# Product Change Notice (PCN)

PCN Number: **PCN-0451520R-01**

Product(s) Affected: PJ-030DH-SMT-TR

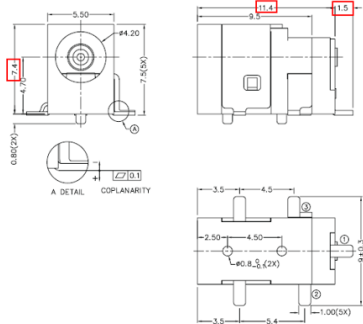
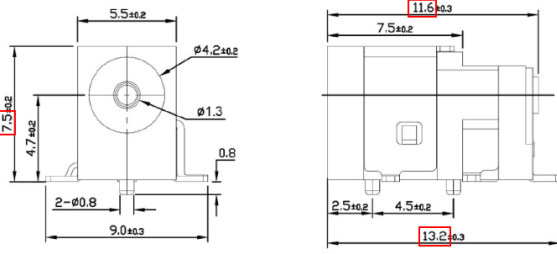
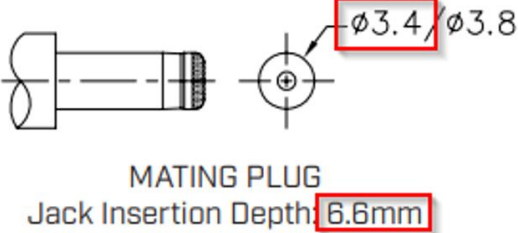
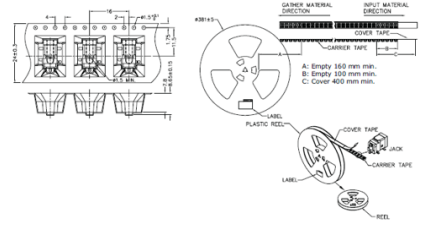
Description of Change: mechanical, material, packaging, and soldering differences as shown below:

PREVIOUS CUI DEVICES DETAIL / IMAGE	NEW CUI DEVICES DETAIL / IMAGE
 <p>Previous detail drawings showing dimensions: 5.50, 4.7, 11.4, 1.5, 4.2, 7.5, 3.5, 4.5, 2.50, 4.50, 1.00(3X), 5.4, 1.00(3X), 1.00(3X).</p>	 <p>New detail drawings showing dimensions: 5.5±0.2, 7.5±0.2, 4.7±0.2, 0.8, 2-∅0.8, 9.0±0.3, ∅4.2±0.2, ∅1.3, 11.6±0.3, 7.5±0.2, 2.5±0.2, 4.5±0.2, 13.2±0.3.</p>
 <p>Recommended PCB Layout Top View (Previous): Terminal numbers 1, 2, 3; dimensions 11.1, 2.4, 8.0, 3.5, 2.5, 5(2X), 2.5, 2.5, 4.5, 2.75, 2.75, 3.5, 8, 2(5X).</p>	 <p>Recommended PCB Layout Top View (New): Dimensions 3.5, 5.4, 2.5, 5(2X), 2.5, 2.5, 4.5, 1.0*2, 2.75, 2.75, 3.5, 4.5, 5-2, 11.1.</p>

<table border="1"> <thead> <tr> <th></th> <th>MATERIAL</th> <th>PLATING</th> </tr> </thead> <tbody> <tr> <td>center pin</td> <td>copper</td> <td>nickel</td> </tr> <tr> <td>terminal 1</td> <td>brass</td> <td>silver</td> </tr> <tr> <td>terminal 2</td> <td>copper alloy</td> <td>silver</td> </tr> <tr> <td>terminal 3</td> <td>brass</td> <td>silver</td> </tr> <tr> <td>shield</td> <td>cold rolled steel</td> <td>nickel</td> </tr> <tr> <td>plastic</td> <td>PA6T or equivalent</td> <td></td> </tr> </tbody> </table>		MATERIAL	PLATING	center pin	copper	nickel	terminal 1	brass	silver	terminal 2	copper alloy	silver	terminal 3	brass	silver	shield	cold rolled steel	nickel	plastic	PA6T or equivalent		<table border="1"> <thead> <tr> <th>DESCRIPTION</th> <th>MATERIAL</th> <th>PLATING/COLOR</th> </tr> </thead> <tbody> <tr> <td>center pin</td> <td>brass</td> <td>tin</td> </tr> <tr> <td>terminal 1</td> <td>brass t=0.3</td> <td>silver</td> </tr> <tr> <td>terminal 2</td> <td>phosphorus bronze t=0.3</td> <td>silver</td> </tr> <tr> <td>terminal 3</td> <td>brass t=0.4</td> <td>silver</td> </tr> <tr> <td>shield</td> <td>stainless steel</td> <td>nickel</td> </tr> <tr> <td>housing</td> <td>PPA (UL94V-0)</td> <td>black</td> </tr> </tbody> </table>	DESCRIPTION	MATERIAL	PLATING/COLOR	center pin	brass	tin	terminal 1	brass t=0.3	silver	terminal 2	phosphorus bronze t=0.3	silver	terminal 3	brass t=0.4	silver	shield	stainless steel	nickel	housing	PPA (UL94V-0)	black

MATERIAL	PLATING																																															
center pin	copper	nickel																																															
terminal 1	brass	silver																																															
terminal 2	copper alloy	silver																																															
terminal 3	brass	silver																																															
shield	cold rolled steel	nickel																																															
plastic	PA6T or equivalent																																																
DESCRIPTION	MATERIAL	PLATING/COLOR																																															
center pin	brass	tin																																															
terminal 1	brass t=0.3	silver																																															
terminal 2	phosphorus bronze t=0.3	silver																																															
terminal 3	brass t=0.4	silver																																															
shield	stainless steel	nickel

housing	PPA (UL94V-0)	black																																															
 <p><b>MATING PLUG</b> Jack Insertion Depth: 6.6mm</p>	 <p><b>MATING PLUG</b> Jack Insertion Depth: 6.5mm</p>																																																
<p><b>SOLDERABILITY</b></p> <table border="1"> <thead> <tr> <th>parameter</th> <th>conditions/description</th> <th>min</th> <th>typ</th> <th>max</th> <th>units</th> </tr> </thead> <tbody> <tr> <td>reel storage</td> <td>at relative humidity &lt;80%</td> <td></td> <td></td> <td>40</td> <td>°C</td> </tr> <tr> <td>reflow soldering<sup>1</sup></td> <td>see reflow profile</td> <td>255</td> <td>260</td> <td>265</td> <td>°C</td> </tr> <tr> <td>drying conditions<sup>2</sup></td> <td>parts in reel: bake at 40°C ±5°C for 72 hours parts removed from reel: bake at 40°C ±5°C for 10 hours</td> <td></td> <td></td> <td></td> <td></td> </tr> </tbody> </table> <p>Note:      1. Must reflow solder within 72 hours from opening vacuum packaging at a temperature &lt;30°C &amp; relative humidity &lt;60%.      2. When exceeding floor life by &gt;72 hours.</p> 	parameter	conditions/description	min	typ	max	units	reel storage	at relative humidity <80%			40	°C	reflow soldering <sup>1</sup>	see reflow profile	255	260	265	°C	drying conditions <sup>2</sup>	parts in reel: bake at 40°C ±5°C for 72 hours parts removed from reel: bake at 40°C ±5°C for 10 hours					<p><b>SOLDERABILITY</b></p> <table border="1"> <thead> <tr> <th>parameter</th> <th>conditions/description</th> <th>min</th> <th>typ</th> <th>max</th> <th>units</th> </tr> </thead> <tbody> <tr> <td>reel storage</td> <td>10-30°C, &lt;70% humidity</td> <td></td> <td></td> <td></td> <td>°C</td> </tr> <tr> <td>reflow soldering<sup>1</sup></td> <td>see reflow profile</td> <td>255</td> <td>260</td> <td></td> <td>°C</td> </tr> <tr> <td>drying conditions<sup>2</sup></td> <td>parts in reel: bake at 110°C for 4 hours parts removed from reel: bake at 110°C for 4 hours</td> <td></td> <td></td> <td></td> <td></td> </tr> </tbody> </table> <p>Note:      1. CUDEVICES recommends to solder within 72 hours from opening vacuum packaging at a temperature &lt;30°C &amp; relative humidity &lt;60%.      2. When exceeding floor life by &gt;48 hours.</p> 	parameter	conditions/description	min	typ	max	units	reel storage	10-30°C, <70% humidity				°C	reflow soldering <sup>1</sup>	see reflow profile	255	260		°C	drying conditions <sup>2</sup>	parts in reel: bake at 110°C for 4 hours parts removed from reel: bake at 110°C for 4 hours

parameter	conditions/description	min	typ	max	units																																												
reel storage	at relative humidity <80%			40	°C																																												
reflow soldering <sup>1</sup>	see reflow profile	255	260	265	°C																																												
drying conditions <sup>2</sup>	parts in reel: bake at 40°C ±5°C for 72 hours parts removed from reel: bake at 40°C ±5°C for 10 hours																																																
parameter	conditions/description	min	typ	max	units																																												
reel storage	10-30°C, <70% humidity				°C																																												
reflow soldering <sup>1</sup>	see reflow profile	255	260		°C																																												
drying conditions <sup>2</sup>	parts in reel: bake at 110°C for 4 hours parts removed from reel: bake at 110°C for 4 hours
